Pine Knoll Recreation Area

Town of East Longmeadow ADA Transition Plan

October 2025

Institute for Human Centered Design

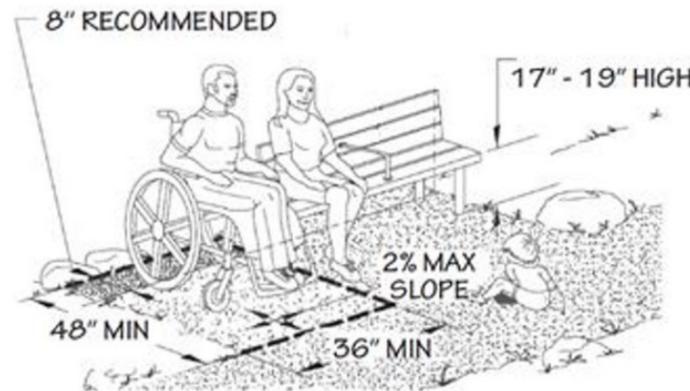
- Recommend providing a 36" min. by 48" min. stable, firm and slip-resistant surface adjacent to at least one bench in each area where benches are provided positioned to allow a person in a wheeled mobility device and a person sitting on the bench to have their shoulders aligned. See the following diagram:

Changing room

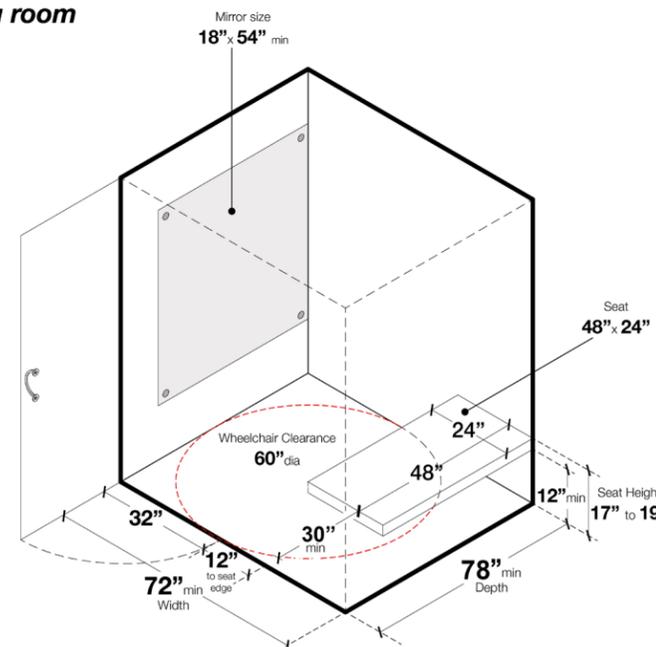
- In the men's and women's toilet and changing rooms, recommend providing an accessible private changing stall that is 78" by 72" min. See the following diagram:

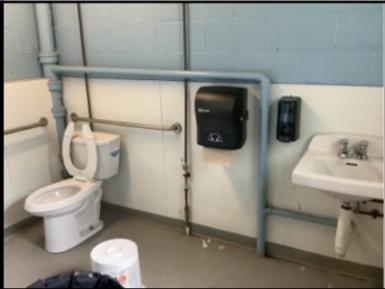
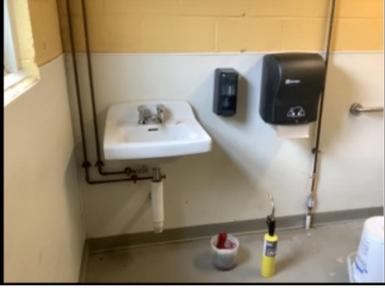
2310	
64	Near Birch Hall	Ext.		Picnic Tables	N/A		Picnic table not on an accessible route	-	Ensure that the picnic table is connected to an accessible route. Recommendation applies to all picnic tables with a similar issue.	1	-	-
65	Near Birch Hall	Ext.		Picnic Tables	N/A		Picnic table not on an accessible route Knee clearance less than 19" deep	4.1% cross x 7.3% run 15.5"	Ensure that the picnic table is connected to an accessible route. Provide at least one picnic table with knee clearance that is 19" deep min. (Cost estimate is for an accessible picnic table.)	1	2310	\$1K - \$5K
											2310
